Access Compliance Report

Public Rights-of-Way

(Curb Ramps)

Intersection ID: 3584	Main Street: DIXIE_ANN_DR	Cross Street: CHOWNING_TAVERN_LN	Location: NW
ADA ID: 409C3DD0650B	Ramp Type: PerpDiag	Initial Pass/Fail: Fail	Overall Compliance: No
Severity Score: 21.25			
Codes/Mitigation Info/Possible Solution		Field Measurements/Component Compliance

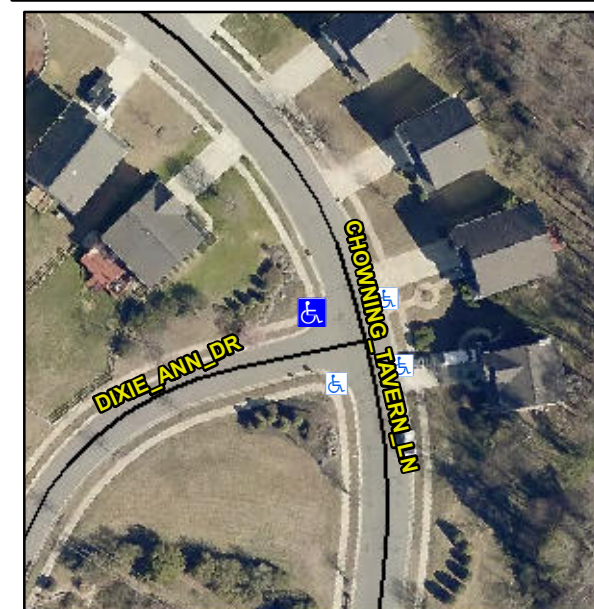
Not Found, R304.5.1, R304.5.3

Compliance	Description	Data	Compliance	Description	Data
N/A	Ramp Length (in)	49.0	Yes	Ramp Slope (%)	5.0
No	Ramp Width (in)	44.0	No	Ramp XSlope (%)	6.0
N/A	Flare Type LT	N/A	N/A	Flare Type RT	N/A
N/A	Flare Slope LT (%)	N/A	N/A	Flare Slope RT (%)	N/A
N/A	Flare Traversable LT?	N/A	N/A	Flare Traversable RT?	N/A
N/A	Landing Length (in)	N/A	N/A	DWS Provided?	N/A
N/A	Landing Width (in)	N/A	N/A	DWS Contrast?	N/A
N/A	Landing Slope (%)	N/A	N/A	DWS Length (in)	N/A
N/A	Landing X Slope (%)	N/A	N/A	DWS Full Width?	N/A
N/A	Landing Curb? (Y/N)	N/A	N/A	DWS Offset (in)	N/A
N/A	Shared Landing?	N/A			
N/A	Gutter Ponding?	N/A	N/A	Gutter Slope (%)	N/A
N/A	Gutter Lip Ht (in)	N/A	N/A	Gutter X Slope (%)	N/A
N/A	Painted X Walk1?	No	N/A	Painted X Walk2?	No
	X Walk 1 Direction	To S		X Walk 2 Direction	To E
N/A	X Walk 1 Width (in)	N/A	N/A	X Walk 2 Width (in)	N/A
	X Walk 1 Slope (%)	1.6		X Walk 2 Slope (%)	3.5
	X Walk 1 X Slope (%)	4.1		X Walk 2 X Slope (%)	3.2

Remove & Replace Curb Ramp With Two New Directional Ramps or Equivalent.
